SUBJECT: W.P. 231-61 Now W.P. 21-65
Site 38C-29
Windermere River Bridge
15.3 Mi. North of Hwy. 101
Sec. Rd. 651 - Dist. 18

**FOUNDATION INVESTIGATION REPORT BY GECCON, LTD. -
Proposed Windermere River Bridge on Hwy. #651,
South of Sault Ste. Marie, Ontario, District #18.
W.P. 21-65**

Windermere River Bridge,
15.3 Miles N. of Hwy. 101,
Hwy. 651, District #18,
W.P. 21-65 (Report by Geocon, Ltd.)

12 66 Re: Soil Conditions and Foundations
Proposed Windermere River Bridge
Sec. Highway 651- W.P. 21-65
Sault Ste. Marie, Ontario

BORE HOLE LOCATIONS & SOIL STRATA

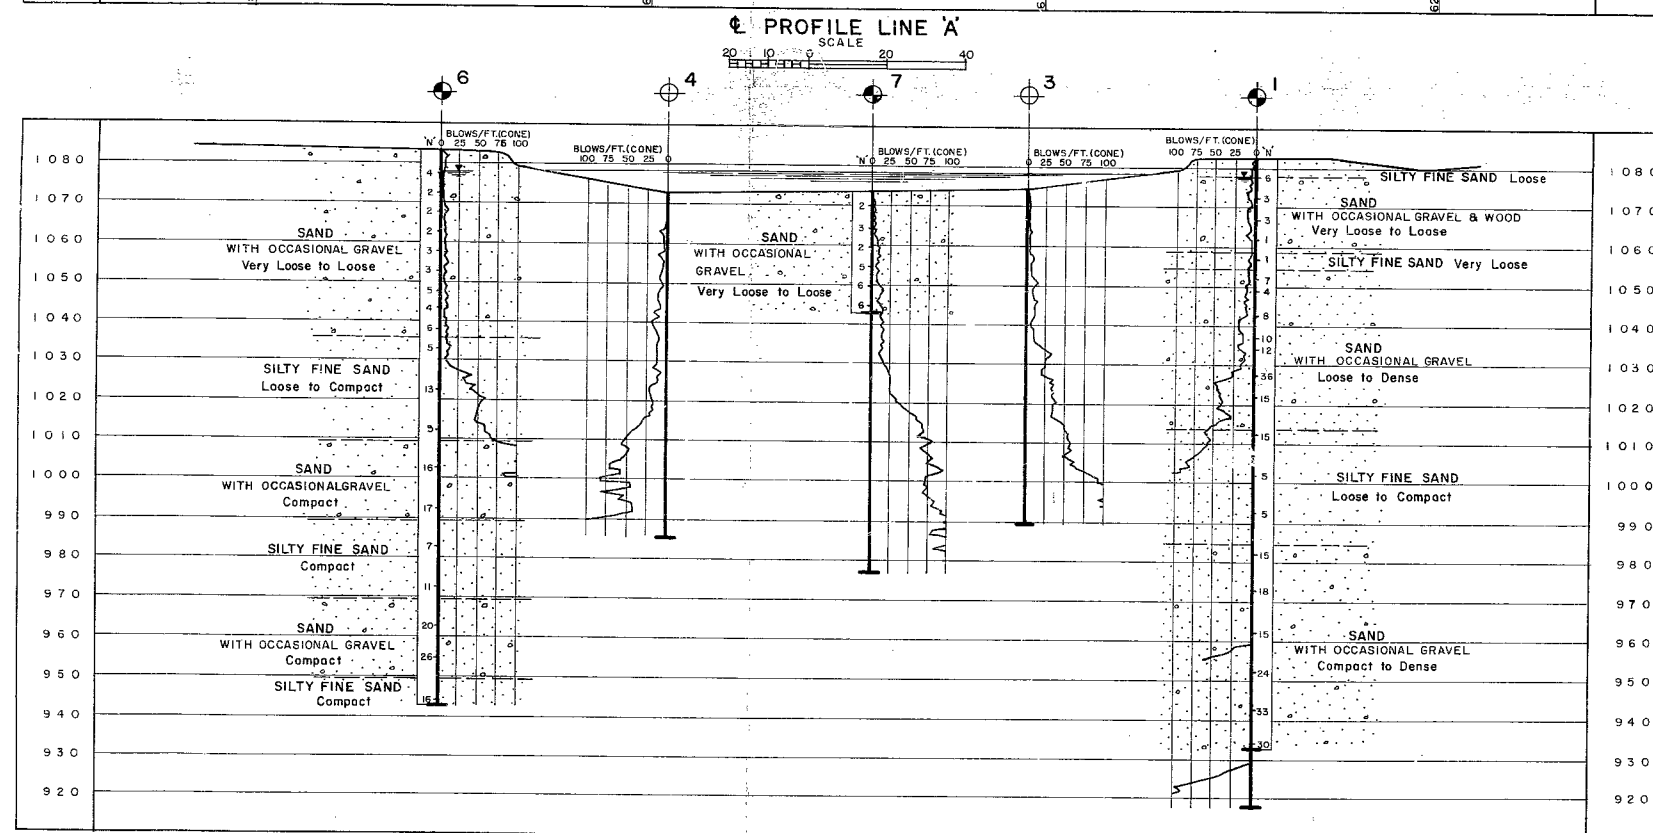
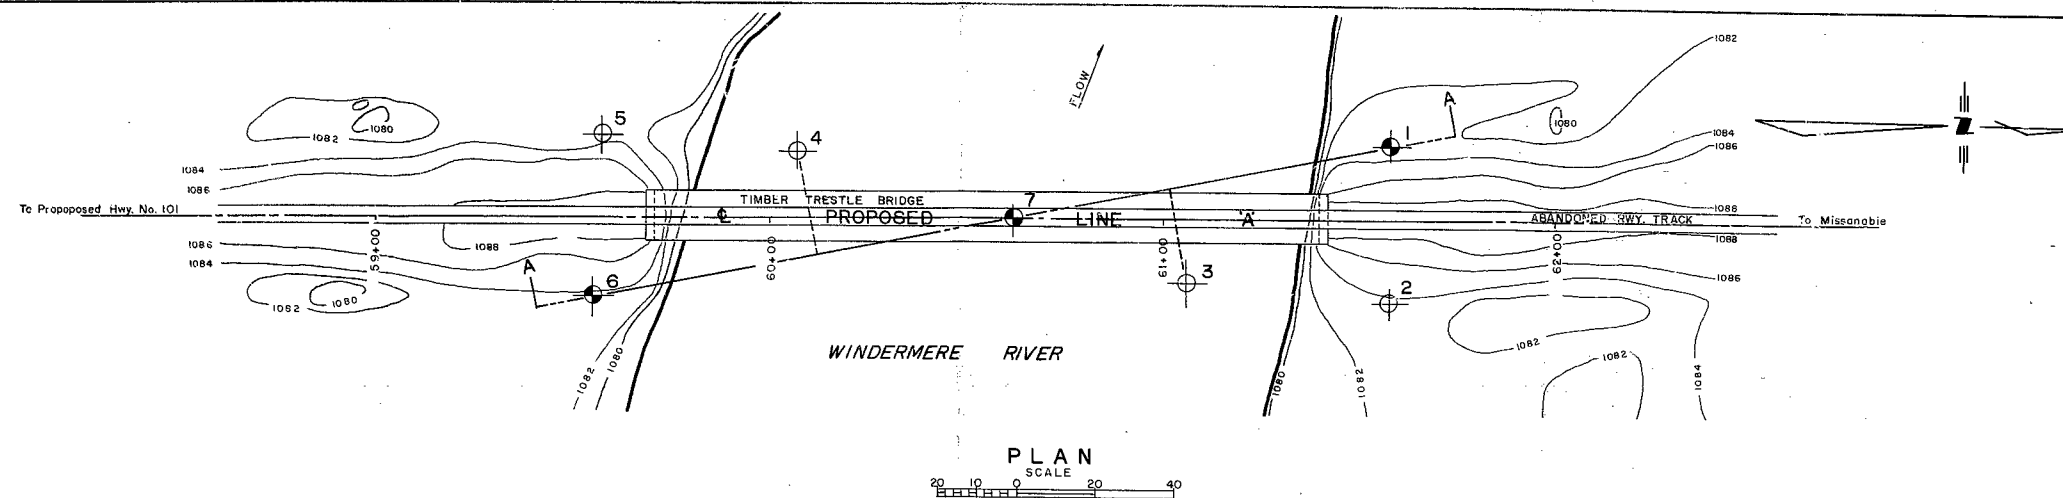
50 TONS/PILE ABOUT 960.
52 TONS/PILE 3 PILES 900.

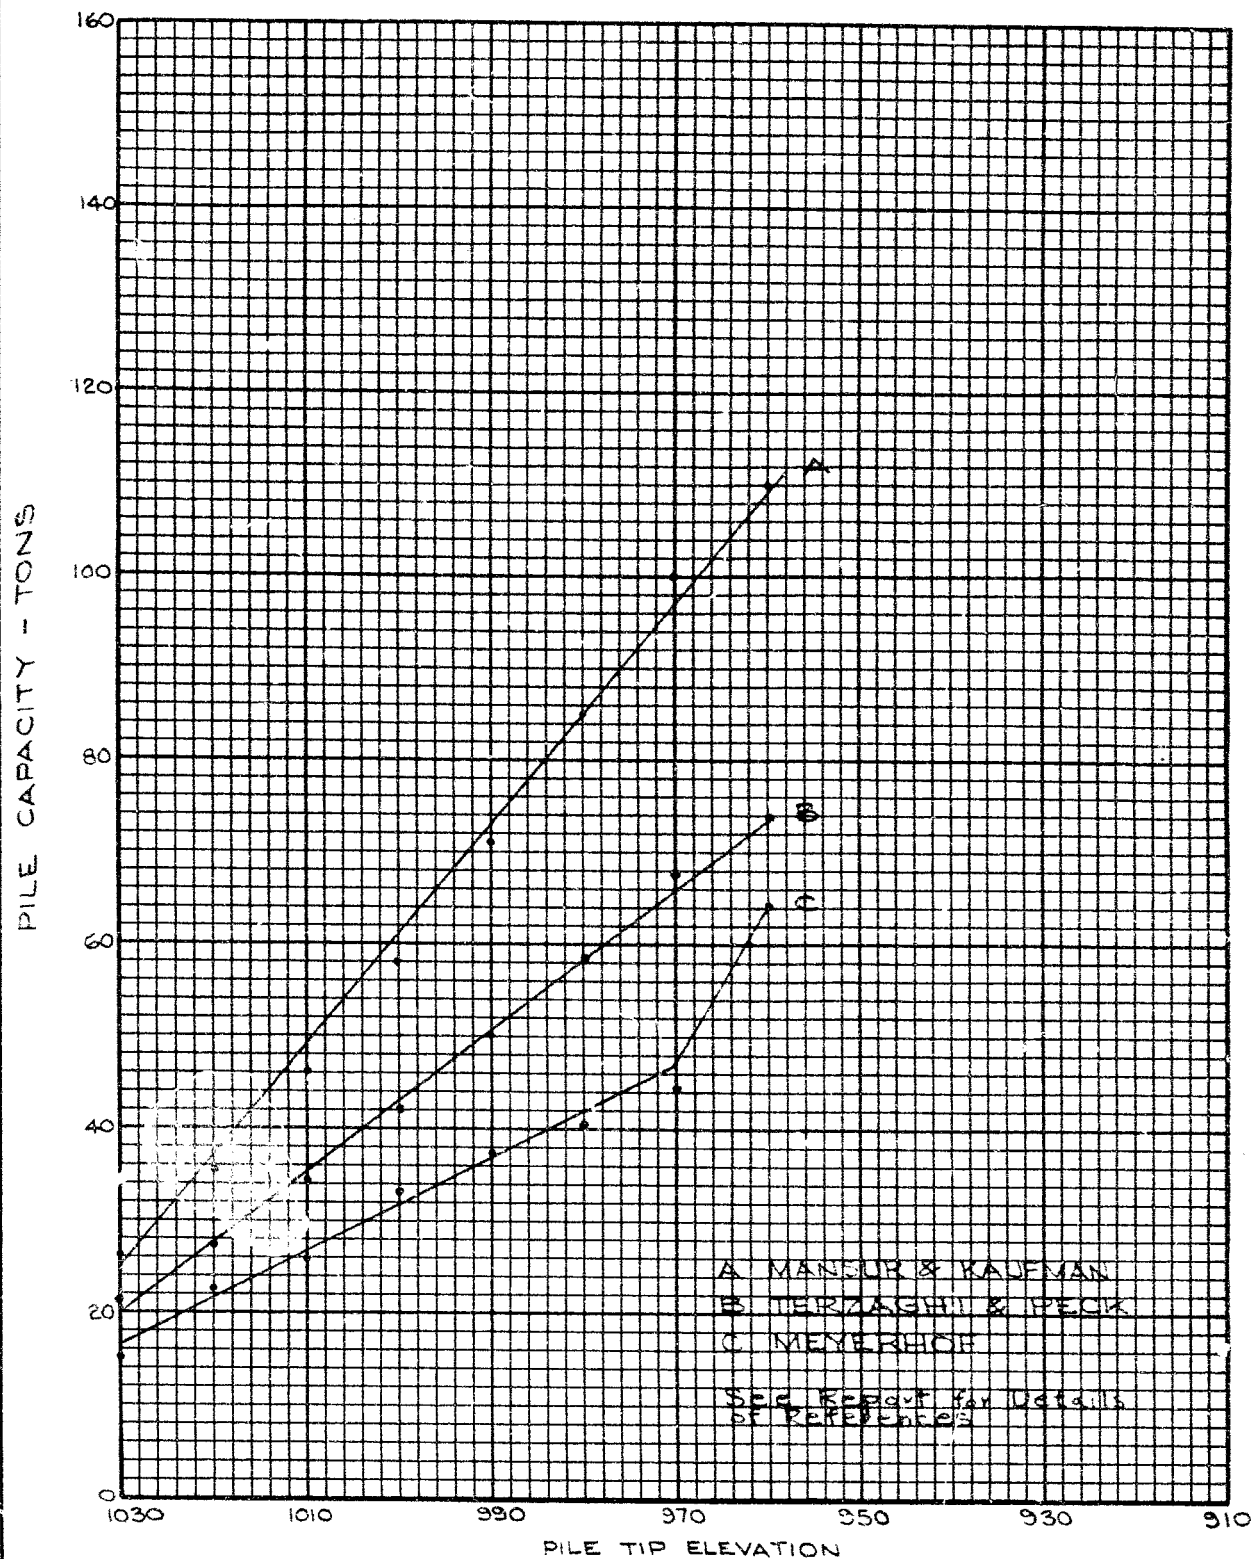
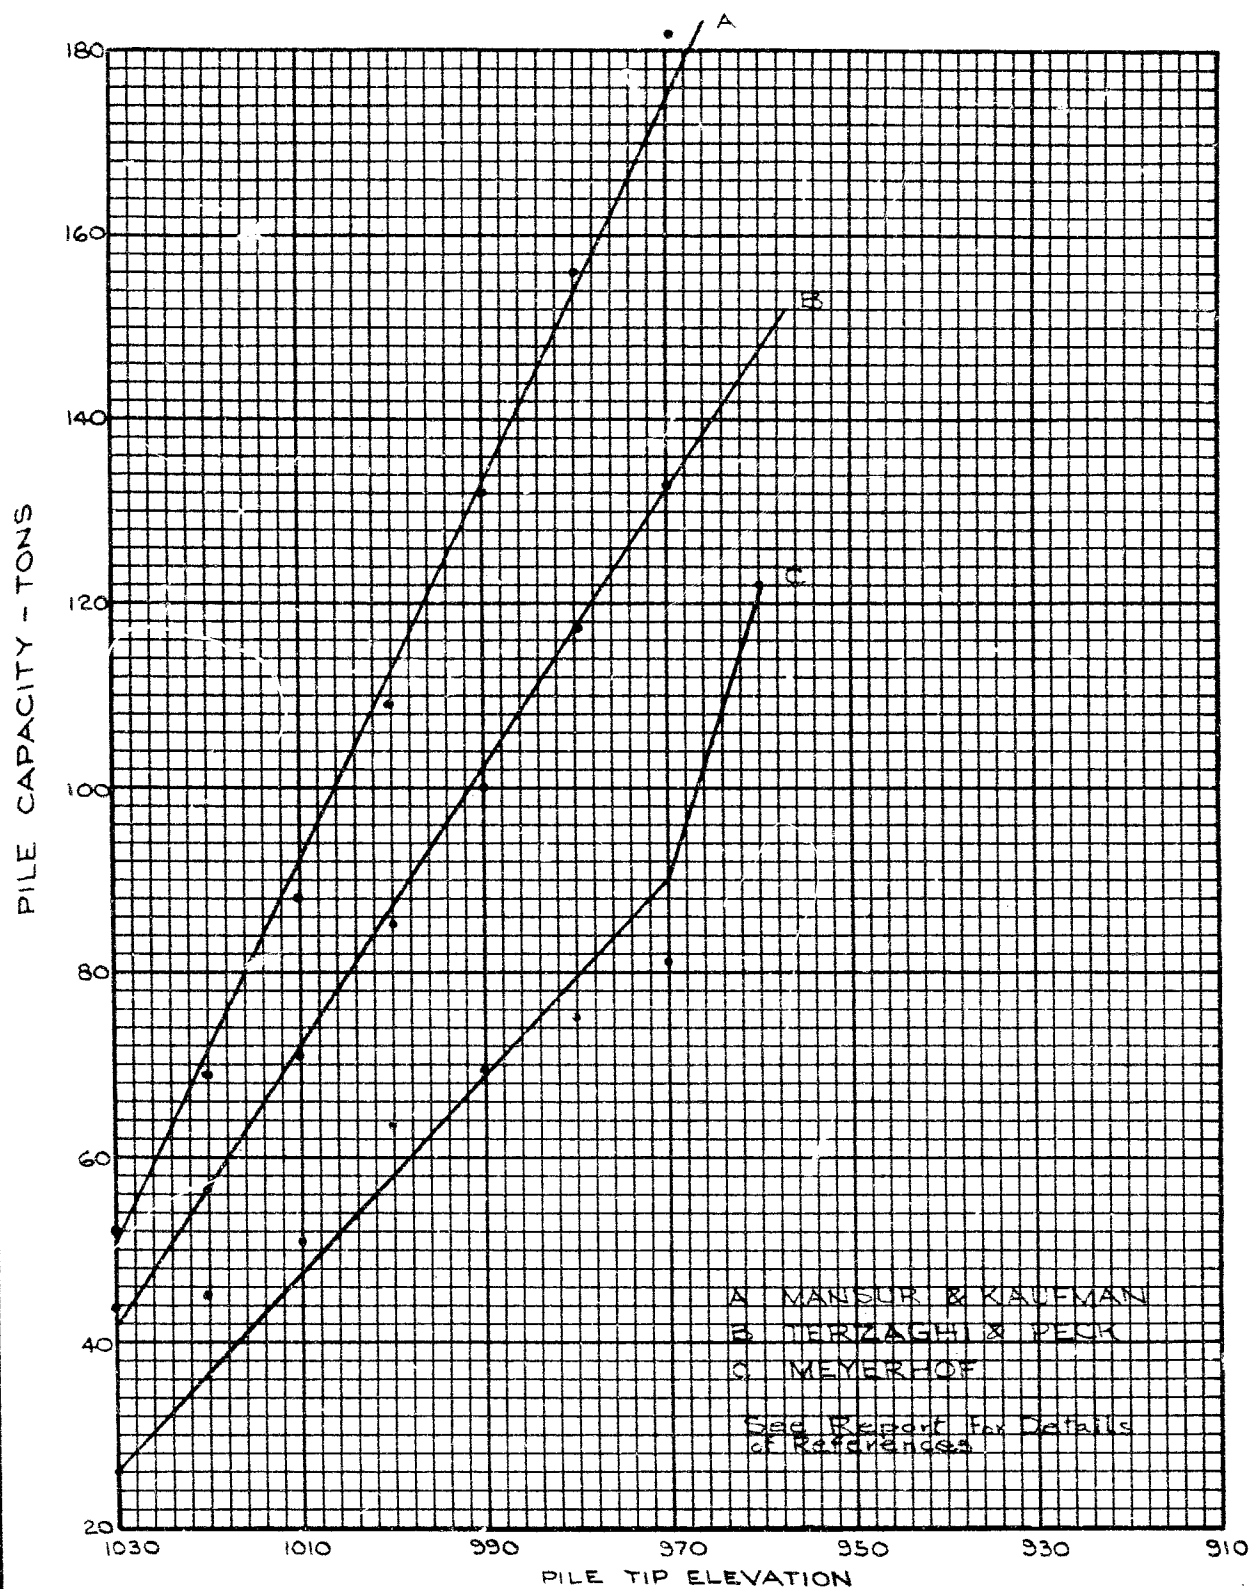
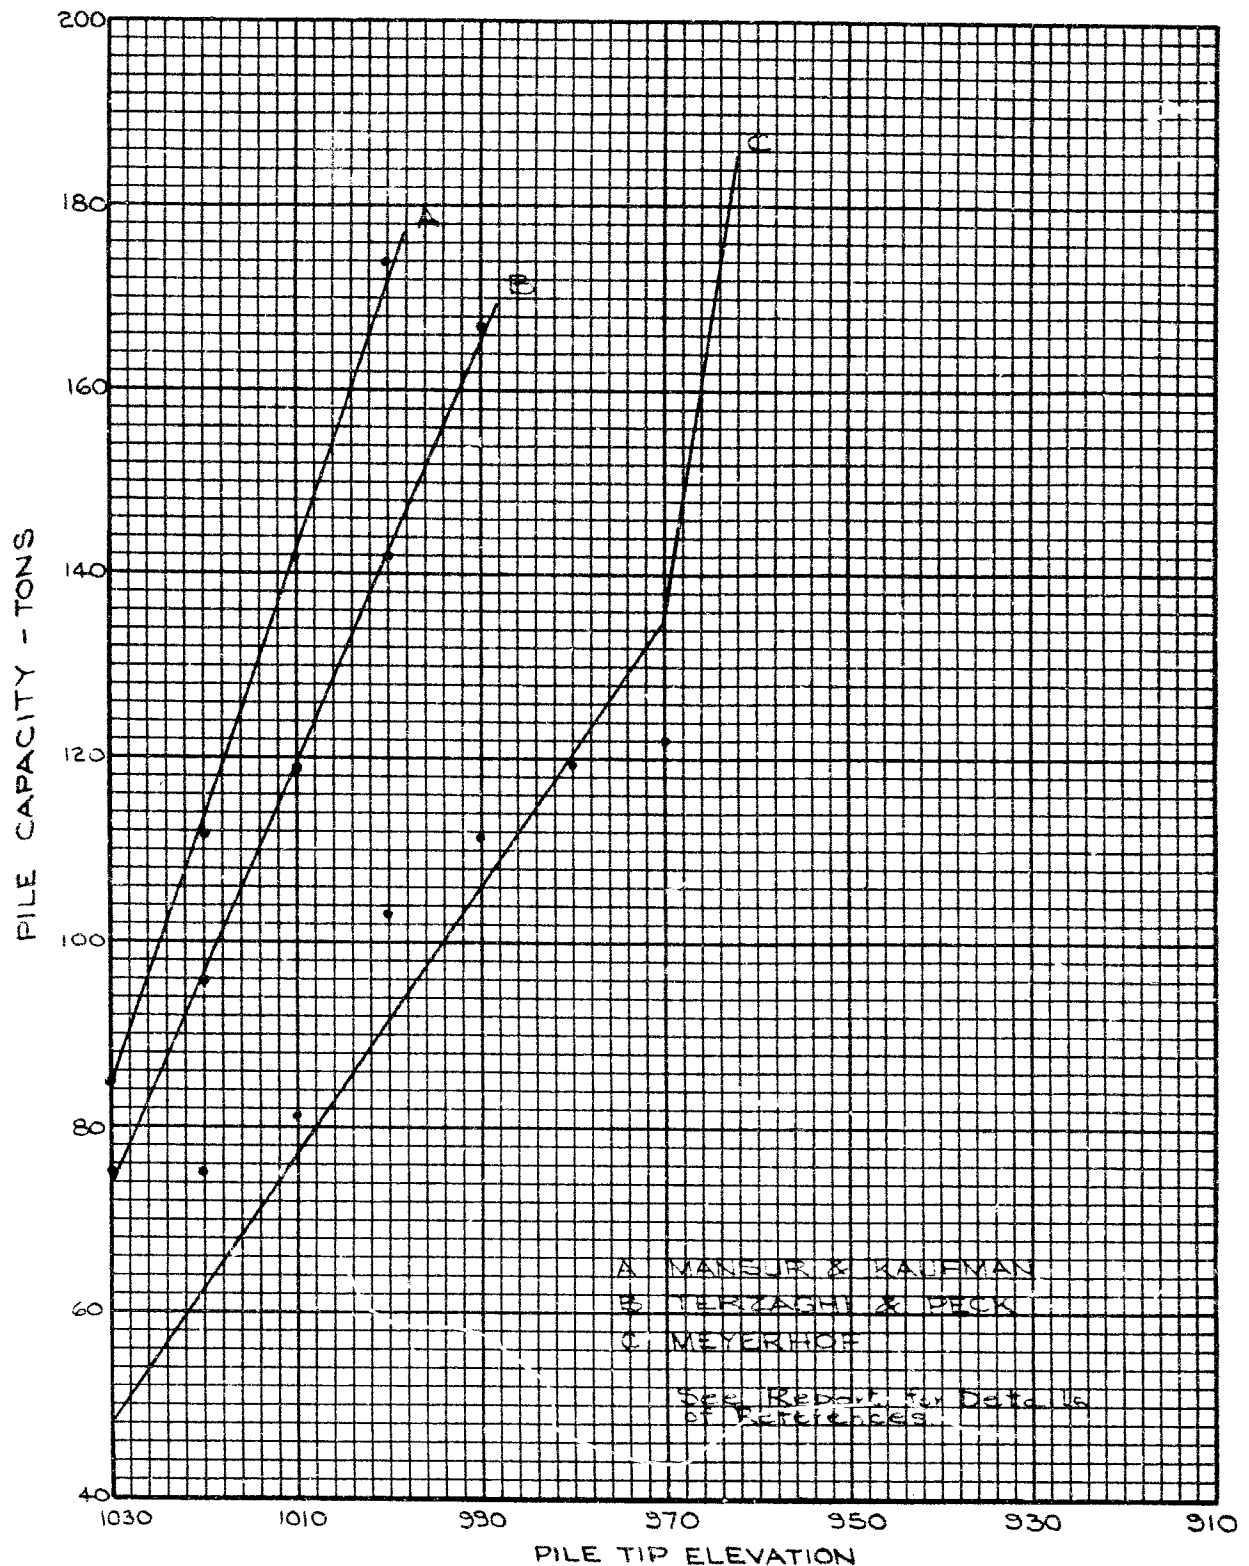
The Consultant has recommended piled foundations for the proposed structure and has prepared several tables showing theoretical capacities for various pile sizes. Our experience has shown that in this particular type of soil with an apparently low relative density, actual pile capacities are generally higher than the theoretical capacities. We would strongly recommend, therefore, that pile load tests be carried out in order to ascertain the most suitable type of pile and the appropriate design loads. For preliminary design purposes, we would suggest that the values from Meyerhof's equation given in the Consultant's table be used.
